Service Bulletin

NO:HIFI2-01-002

SUBJECT: MD disc will not Eject

MODEL (S): MDS-JA20ES

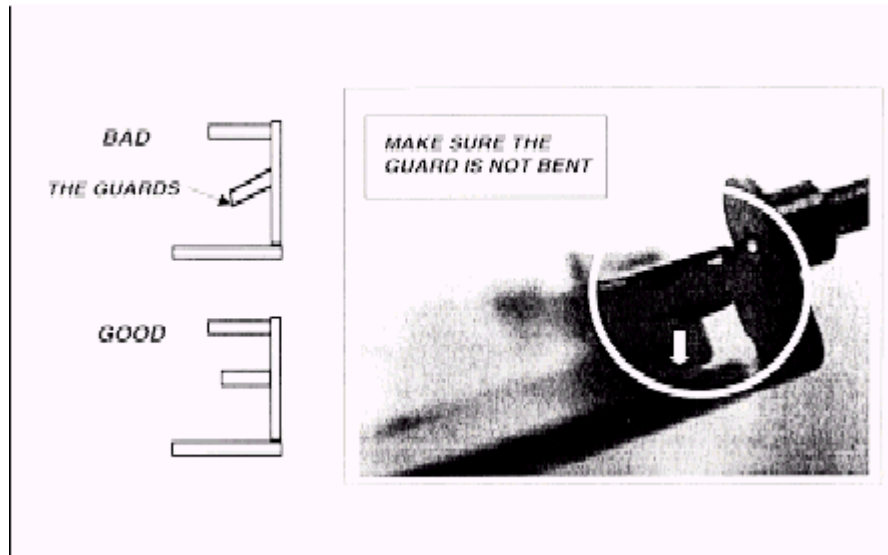
Symptom: Customer complaint states disc does not eject.

Apply HANARL SFL-9 grease (P/N 7-400-000-00) to HOLDER ASSY where indicated.

Make sure the guard is straight before you install the new HOLDER ASSY.

Solution: Replace the HOLDER ASSY with new part (X-4949-789-6).
